OWNER:																
	PWC:																
PROJECT:																	
CAPTIVE POWER PLANT (CPP) PACKAGE VISAKH REFINERY MODERNIZATION PROJECT (VRMP) JOB NO. B016																	
HINDUSTAN PETROLEUM CORPORATION LIMITED																	
ENGINEERS INDIA LIMITED (EIL), NEW DELHI

PROJECT: VRMP PROJECT, VIZAG
NAME OF PACKAGE: CPP package

SL. NO.	COMMENT/ OBSERVATION	RESOLUTION / ACTION
1	DRAWING / DOCUMENT TITLE : 415V SWITCHBOARD (EPMCC-9433) DOCUMENT NUMBER: PY-DL-1-M104-8809-02 R 00 CATEGORY/CODE: 2	
1	Please note that distribution transformer ratings & impedance values, motor ratings etc. mentioned are not reviewed at present. The same shall be as per final complete load data of the package, load analysis, Distribution Transformer Sizing calculations, Cable sizing calculations etc.	
2	Please note that CT ratios for incoming and outgoing feeders are not reviewed at present. These shall be checked / reviewed as per final transformer, motors, and capacitor ratings.	
3	All relays, meters, controls, timers, selector switches etc. as mentioned in bid package hardware data sheets and as required while developing the control schematic and felt necessary for safe operation shall be provid

TABLE-3: 415V EPMCC OUTGOING FEEDER DETAILS.

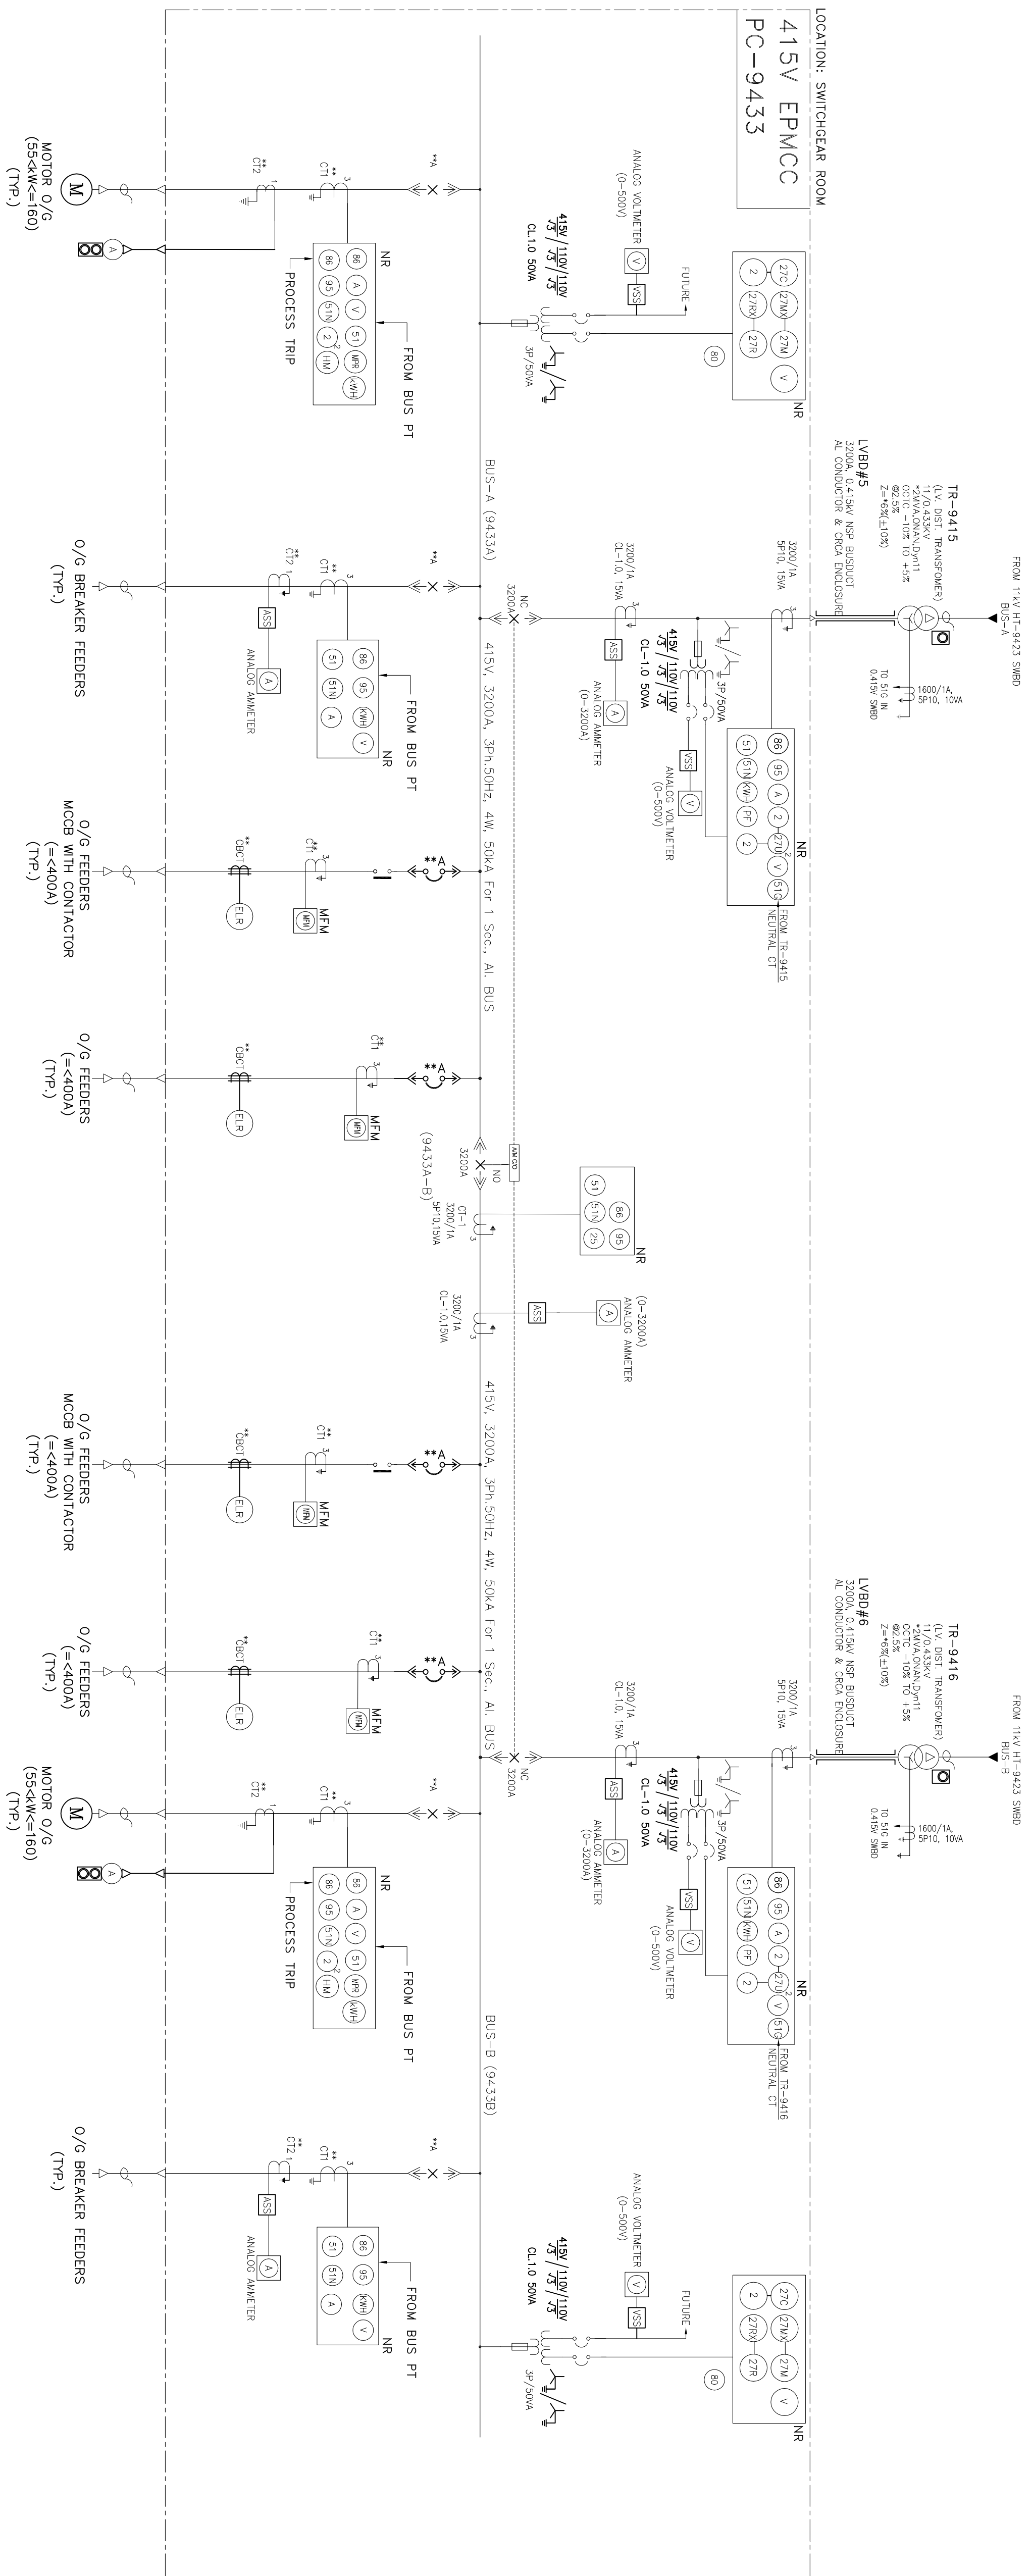
Refer attached file

5	Incomer for solar panel shall be provided with ACB, 4P of minimum rating 800A as per bid package and not MCCB as indicated. M/s BHEL to check and revise.	
6	For solar panel incomer numerical relay shall be provided.	
7	Numerical relays where ever provided for motor feeders shall use in built under voltage relay and timer for delayed tripping on bus under voltage in line with S. No. 14 of Cl. 5.4.3.3 of electrical design basis A758-999-16-50-EDB-1001 attached with tender.	
8	Indicate the Line PT in SLD immediately after the Busduct in the incomer feeders.	
9	MCB in the bus PT shall be 4 Pole. Include this point in Notes.	
10	All super critical application motors shall be provided with double contactors in DOL feeder as per note-3 of clause 5.6.5 of electrical design basis A758-999-16-50-EDB-1001 attached with tender. Indicate a note of the same in SLD.	
11	Break-up of protection components being considered in MPR shall be indicated in the note. U/V+ Timer, E/F protection functions etc. shall also be part of all MPR. MPR functionalities shall be indicated separately for breaker controlled motor feeder. Update drawing Accordingly.

12	In the Legend, instead of MCB indicate it as MCCB.	
13	Indicate a typical outgoing feeder for motors less than 55 kW in SLD. M/s BHEL to clarify motors less than 55 kW will be fed from this EPMCC switchboard or a separate MCC is considered.	
14	Spare feeders at least one number of each type of outgoing feeder or 10% of each type of outgoing feeder whichever is more shall be provided as per clause no. 5.3.4 of EIL specification 6-51-0099. Accordingly, quantity of spare feeders to be checked and indicate the same in revised SLD.	
15	Add note in the SLD "Stabilizing resistor shall be provided in residual earth fault connections for all motors and transformers even in case of numerical relays to prevent any spurious tripping during starting".	
16	metrosils shall be provided for numerical relays to prevent any spurious tripping. Add a note regarding the same.	
17	System architecture shall be IEC61850 HSR. Add this suitably in the notes.

18	Indicate Owner's load in notes, kindly also indicate the same in EPMCC outgoing feeder details.

SL. NO.	COMMENT/ OBSERVATION	RESOLUTION / ACTION
19	Indicate cable sizes in the document.	
20	CLIENT COMMENTS	
	<i>Client comments if any shall be forwarded separately.</i>
